# UNITED STATES PATENT AND TRADEMARK OFFICE

APPLICATION NO.	FILING DATE	FIRST NAMED INVENTOR	ATTORNEY DOCKET NO.	CONFIRMATION NO.
10/642,708	08/18/2003	Jason Werning	35650	4369
116 7590 01/29/2007 PEARNE & GORDON LLP 1801 EAST 9TH STREET SUITE 1200 CLEVELAND, OH 44114-3108			EXAMINER GLUCHOWSKI, KRISTINA R	
			ART UNIT	PAPER NUMBER
			3676

**Office Action Summary**

## DETAILED ACTION

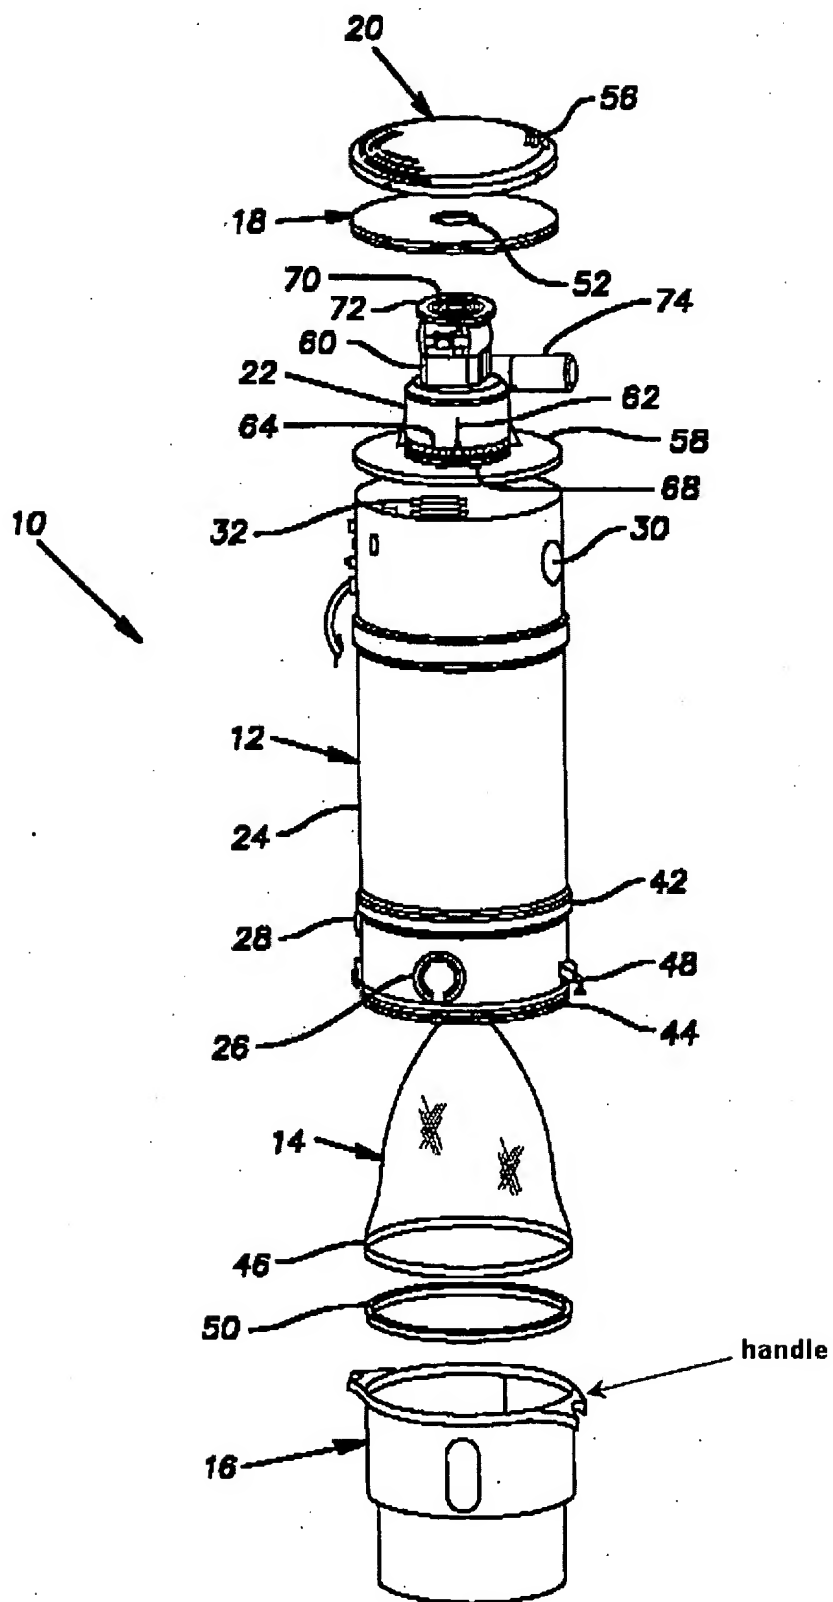
7. Claims 1, 5, 8 and 19-21 are rejected under 35 U.S.C. 102(b) as being anticipated by Fritz et al (US 5813085). Regarding claims 1, 19 and 21, Fritz shows a locking mechanism for a central vacuum system comprising a twist-lock latch (48) configured to receive a handle (see illustration below) of a debris receptacle (16), and a vertical gasket (50) to facilitate an airtight seal between the debris receptacle and a canister (12) of the central vacuum system. The examiner would like to note that a "twist-lock latch" could be any latch. The term "twist-lock" is considered a label in claim 1 since no further structure of the twist lock latch is claimed.

9. Regarding claim 8, the vertical gasket includes a bead roll (see illustration below; lower portion of gasket), the diameter of the bead roll corresponding with a groove (44) formed in an exterior surface of the canister (column 3, lines 30-32).

10. Regarding claim 20, Fritz shows two latches (48) on opposing sides of the canister (see figure 1). See the Fritz device below.

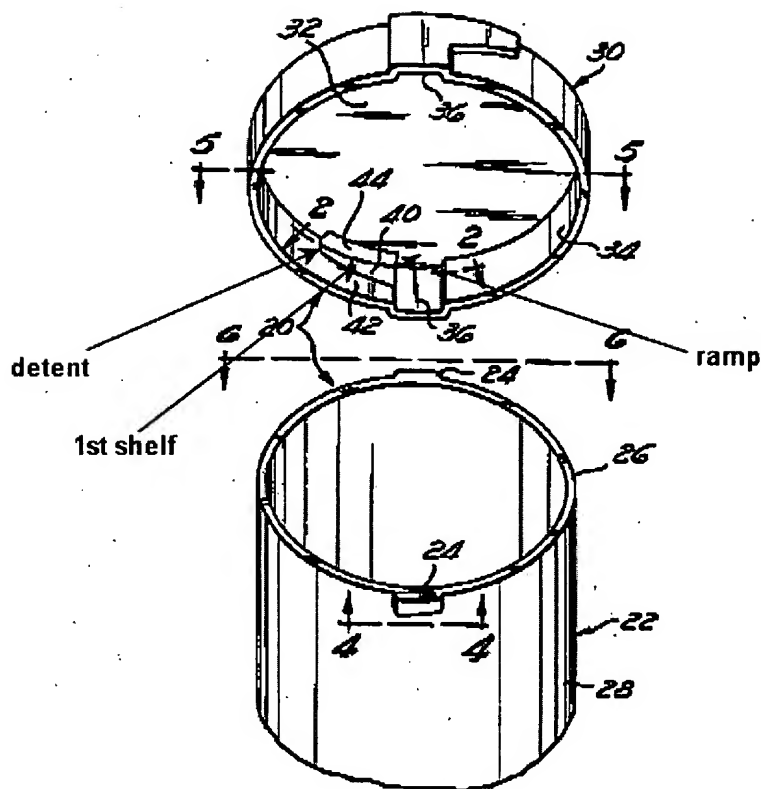
11. Claims 9, 11 and 13 are rejected under 35 U.S.C. 102(b) as being anticipated by Schwartz (US 4279355). Regarding claim 9, Schwartz shows a twist-lock latch comprising a first shelf portion (see illustration below) and a stop detent (see illustration below). The examiner would like to note that "for use in a locking mechanism of a central vacuum system" does not positively claim the combination of the twist-lock latch and the vacuum. "For use" is merely intended use of the structurally claimed apparatus. The claimed structural limitations are met and therefore Schwartz discloses the claimed invention.

12. Regarding claim 11, Schwartz shows a contoured ramp configured to guide the handle into place (see illustration below).

13. Regarding claim 13, the twist-lock latch has no moving parts. See the Schwartz device below.

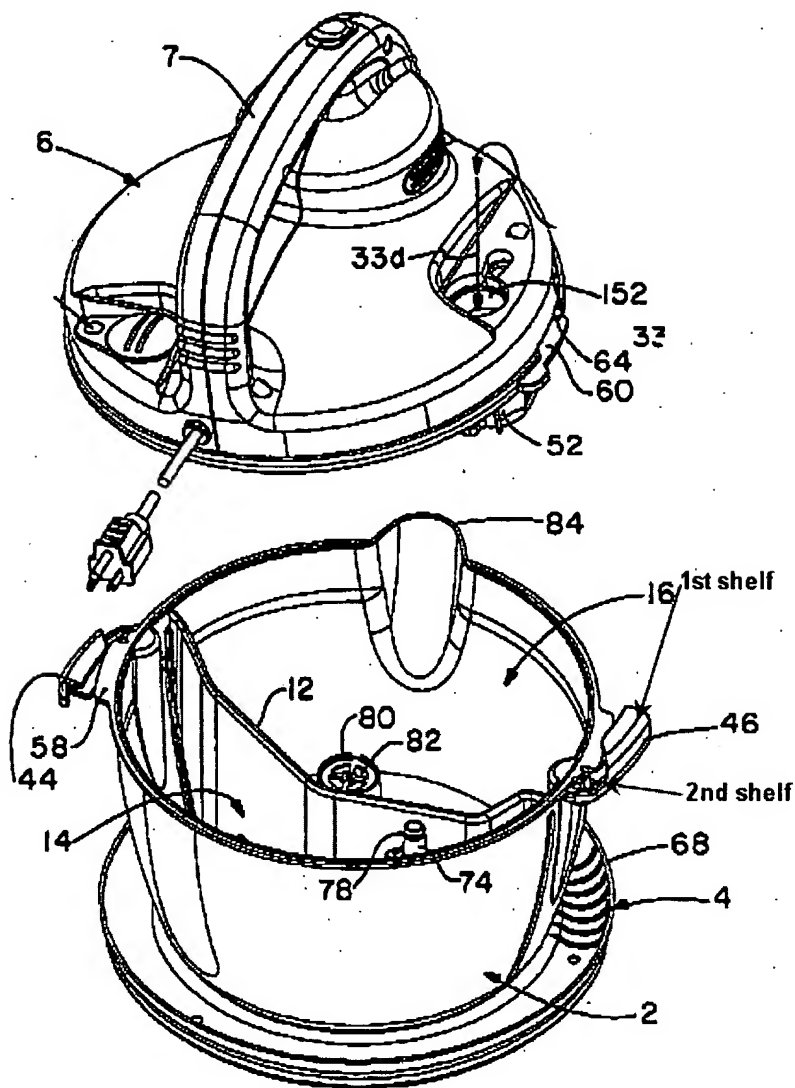
19. Claim 10 is rejected under 35 U.S.C. 103(a) as being unpatentable over Schwartz as applied to claim 9 in view of Crouser (US 6108860). Schwartz fails to show a second shelf portion. Crouser shows that this is well known the art. Crouser shows a latch attaching the debris receptacle (2) to the upper portion (6) wherein the latch has a first and second shelf portion (see illustration below). It would have been obvious to one of ordinary skill in the art at the time of the applicant's invention to include a second shelf portion to prevent damage to the gasket as a result of repetitive use of the latch. The examiner would like to note that because the structural limitations are met, the Schwartz device is capable of performing the claimed functional limitations (ie. to provide clearance for a gasket). See the Crouser device below.
